# Addendum No. 06

April 11, 2024

## BAKERSFIELD COLLEGE STUDENT HOUSING (for DSA Project Name - New Residence Hall)

**PBK PROJECT NO.:** S2103400AR  
**DSA FILE NO.:** 15-C1  
**DSA APPLICATION NO.:** 02-122124

3 BUILDING SECTION EAST - AREA A  
SCALE 3/32" = 1'-0"

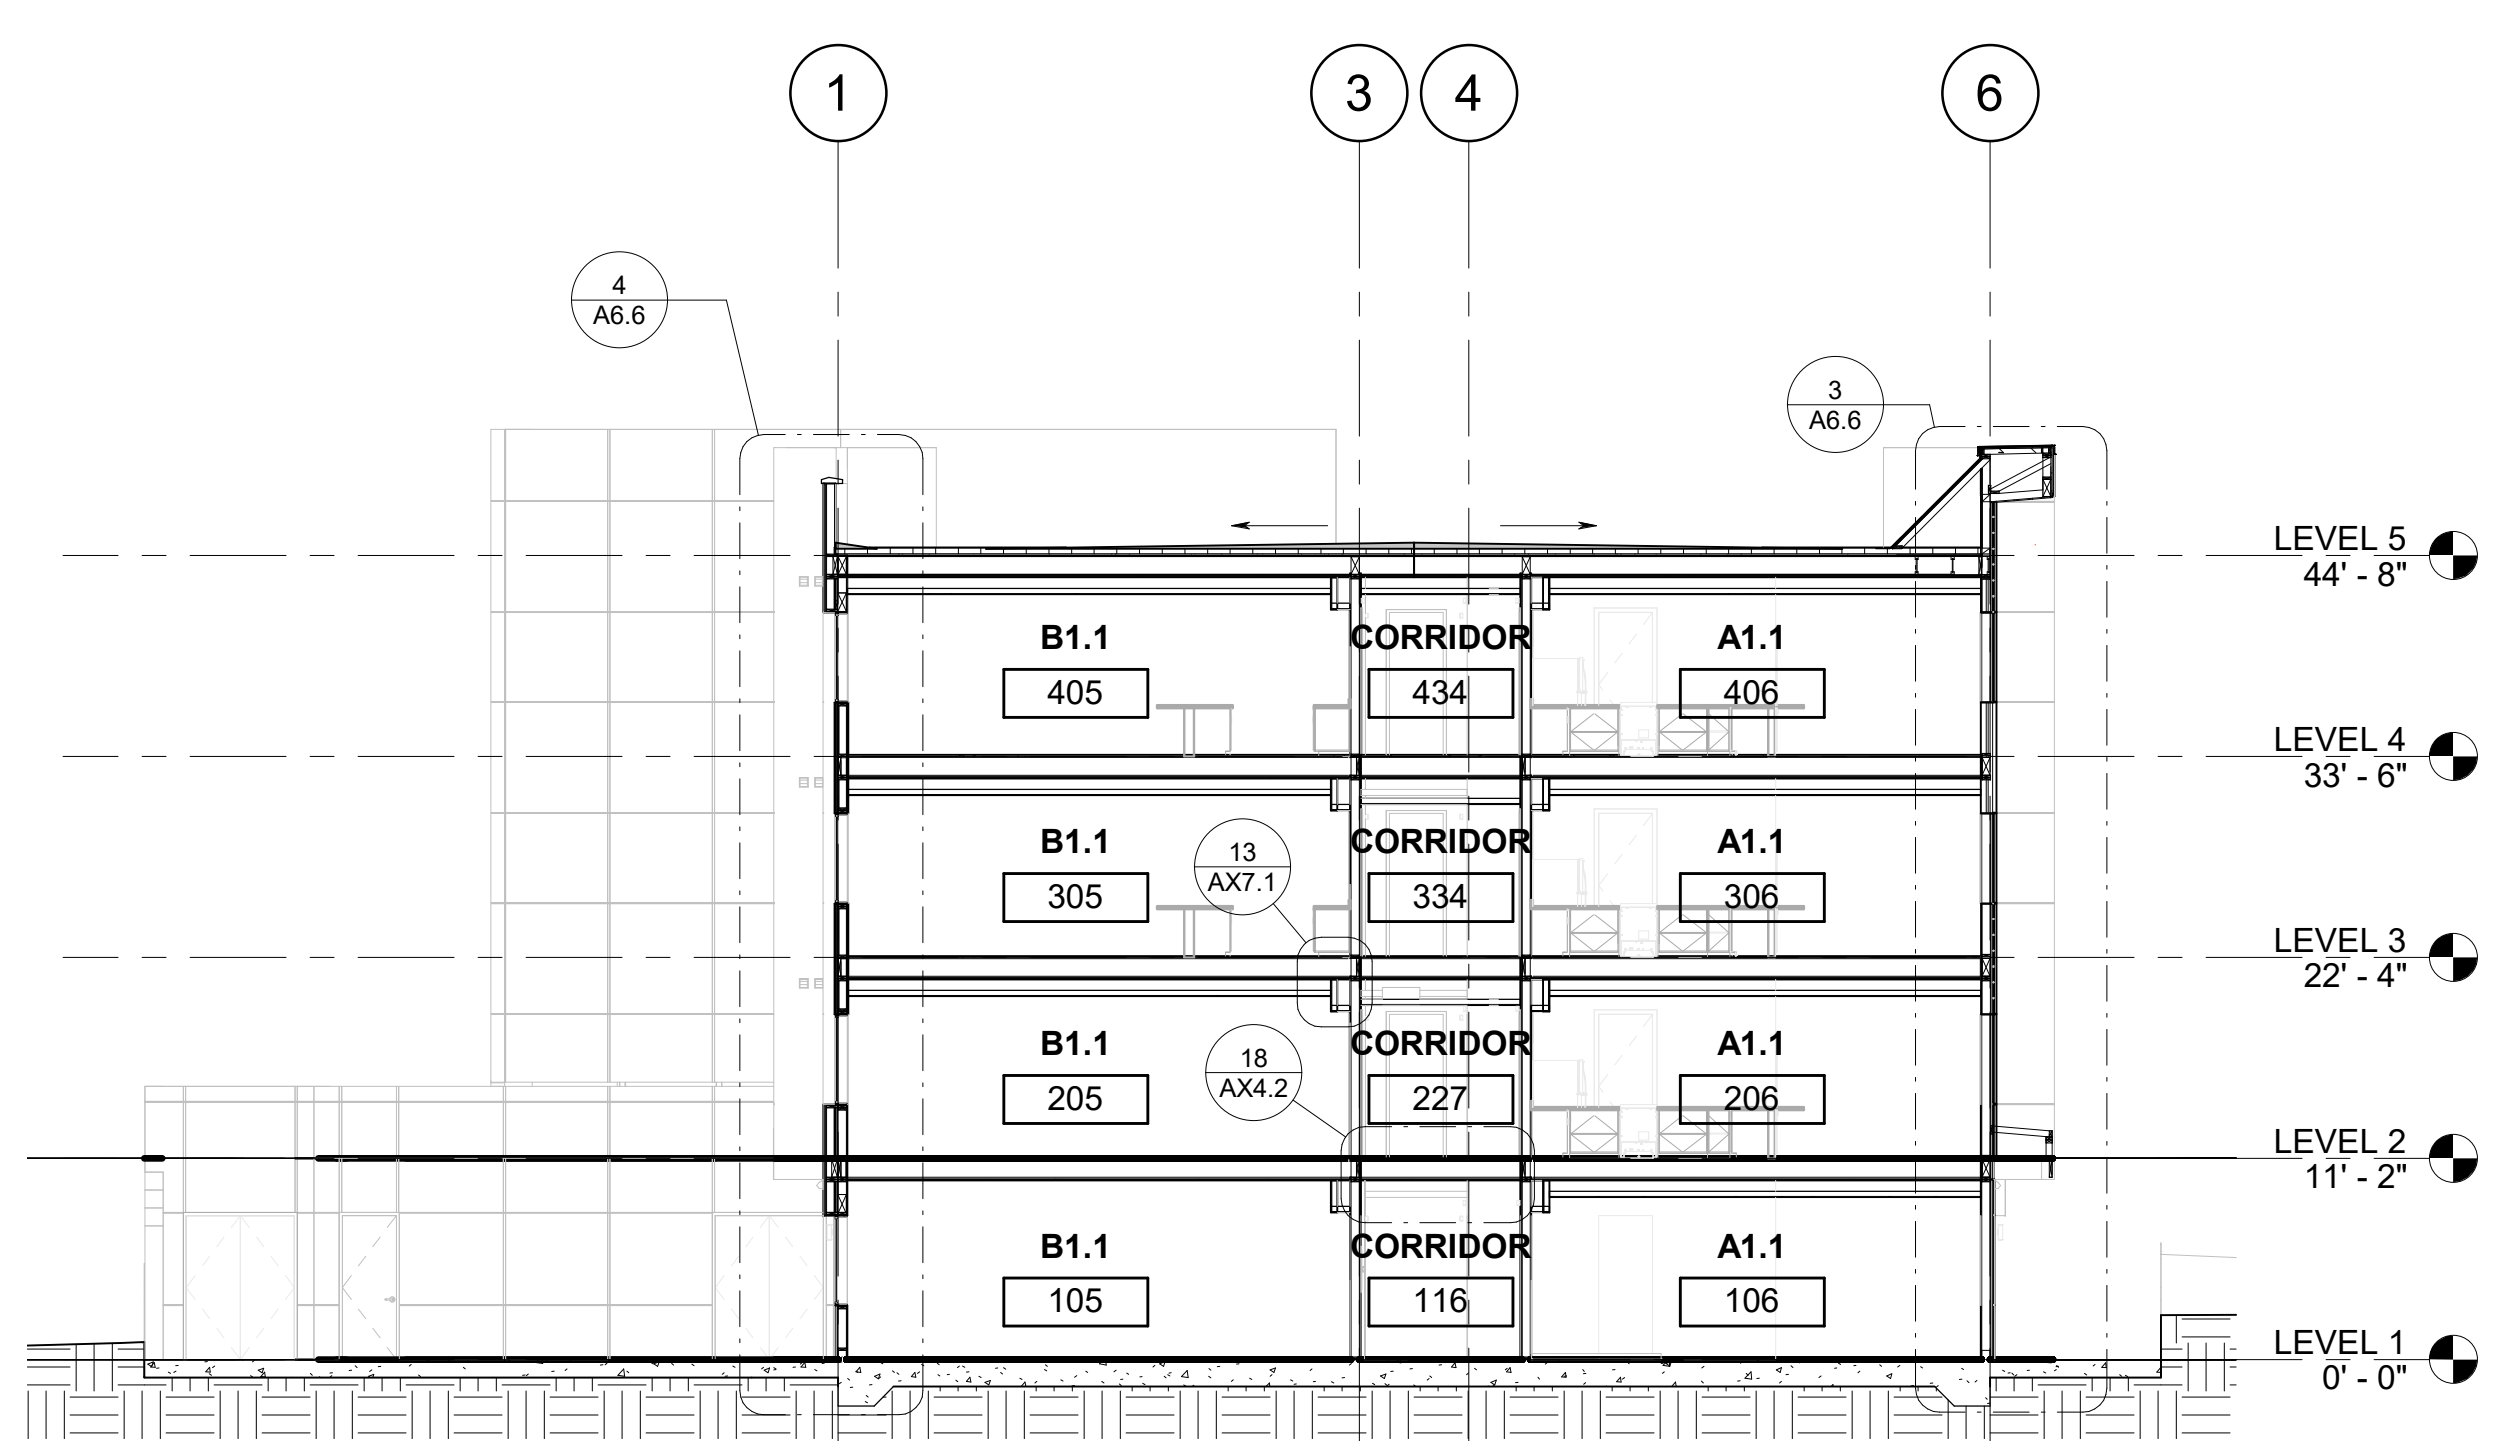
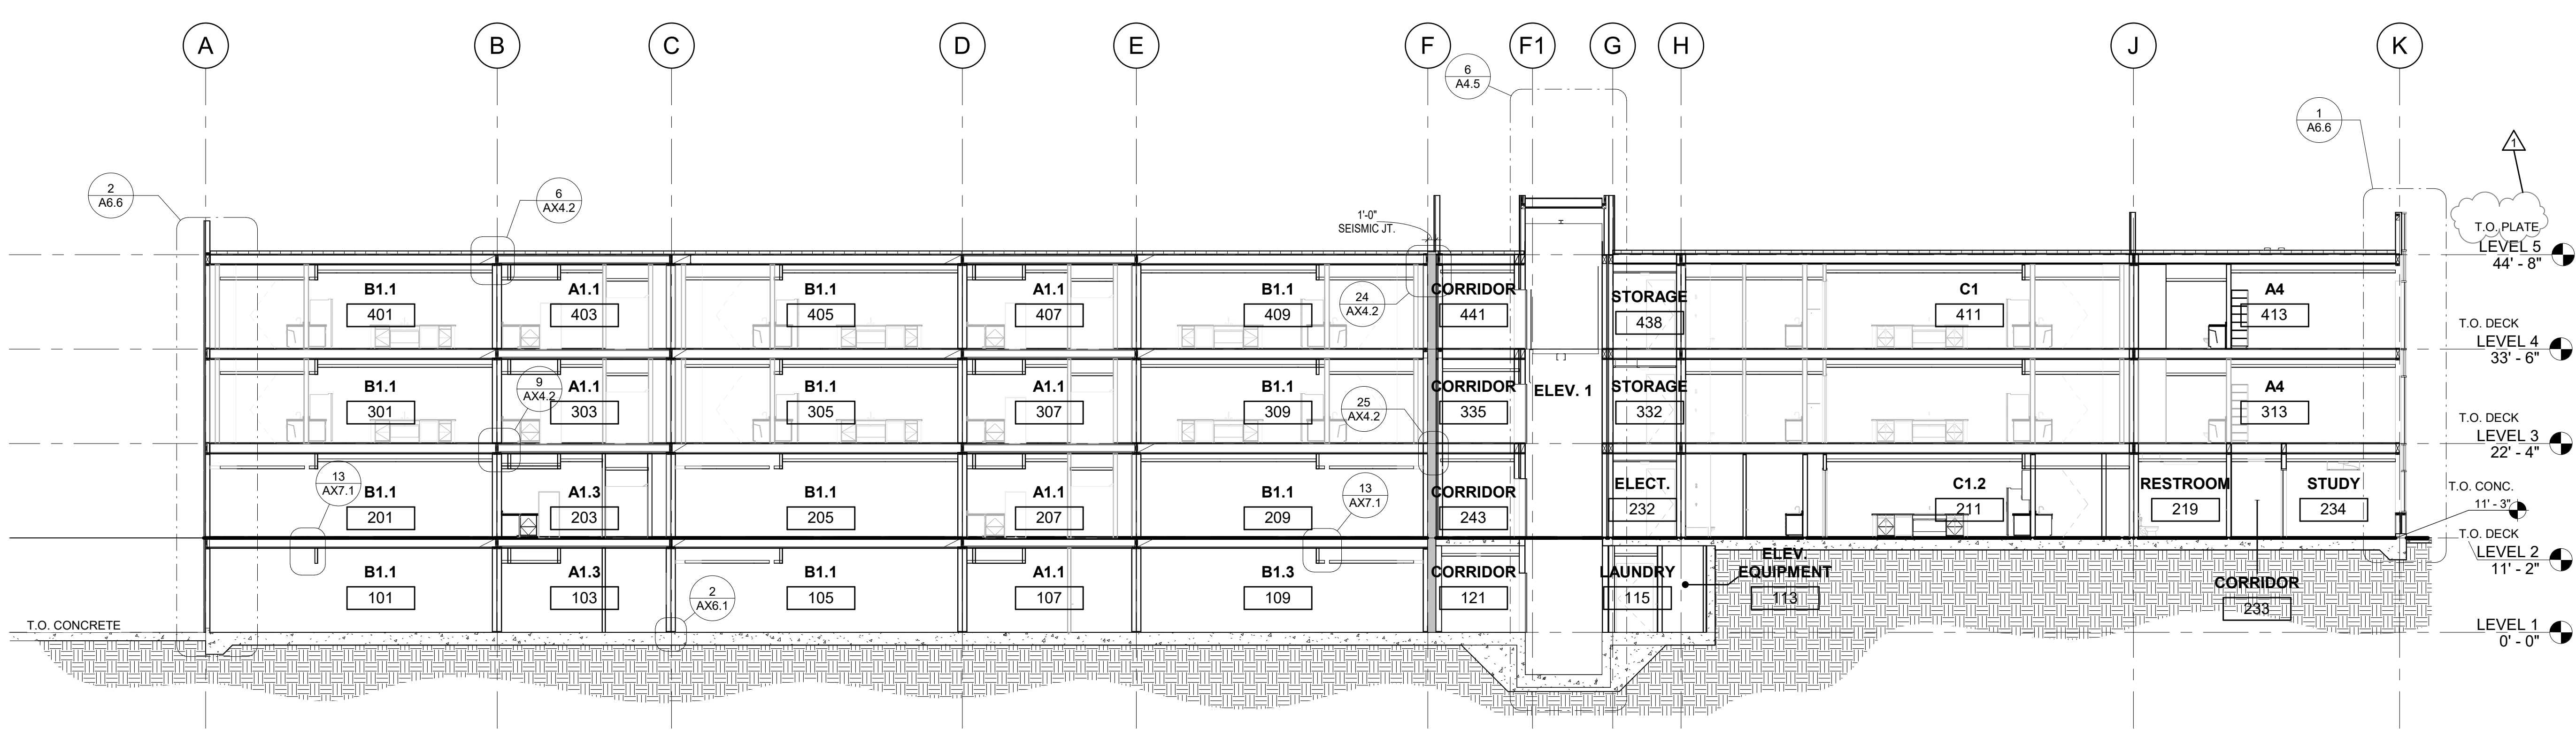
- AD6-16**    **A5.1 – Exterior Elevations:** Replace the sheet in its entirety. Revised detail references and exterior elevation legend. See attached revised drawing A5.1 with all changes clouded.
